DRAWN BY DPK 8-14-2006	Nasco Auscultation Remote Label		
	RCMSC0006N35		
SIZE	FSCM NO.	DWG NO.	REV
SCALE			SHEET

## User's Manual requirement

## Response to Inquiry to FCC (Tracking Number 474491)

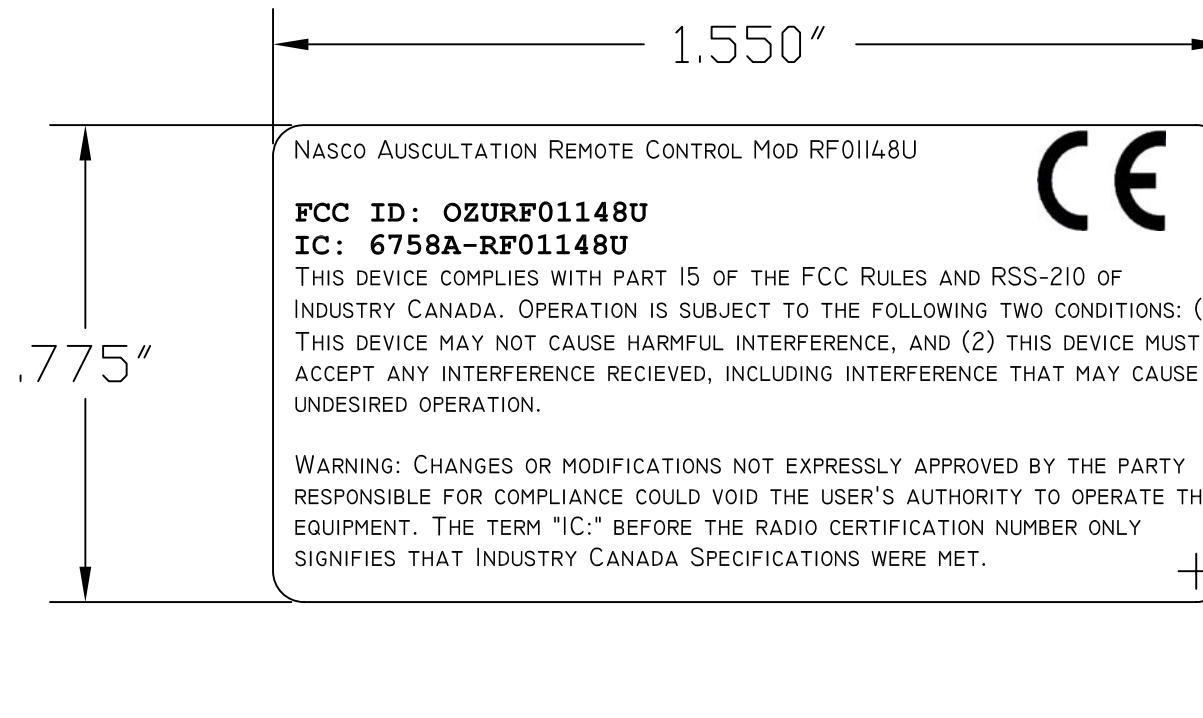
Please address the following two questions. 1) Is it permissible for a Part 15 device to be sold without a users manual (or other paper/electronic document) so long as all required statements (id number, rf hazard and interference warnings, etc...) are placed directly on the device? 2) If all required statements are placed on a device, must a users manual (or other paper/electronic document) be provided when applying for certification? Thanks. JDB

Just to verify I am understanding this correctly. Most applications require a users manual exhibit. However, that exhibit may be comprised of an ID label drawing or photograph, so long as that label clearly demonstrates all information required of the users manual for compliance. Please confirm. JDB

It is permissible to have a device sold without a user's manual, as long as the labeling information (RSS-GEN section 5.2) and the applicable statements (RSS-GEN section 7.1.5) are on the device.

In this case, you do not need to provide a user's manual with your application.

Your understanding is correct. Since the manufacturer does not supply an actual user manual, ! then they may use the product label which contains the required FCC information as a user manual exhibit.
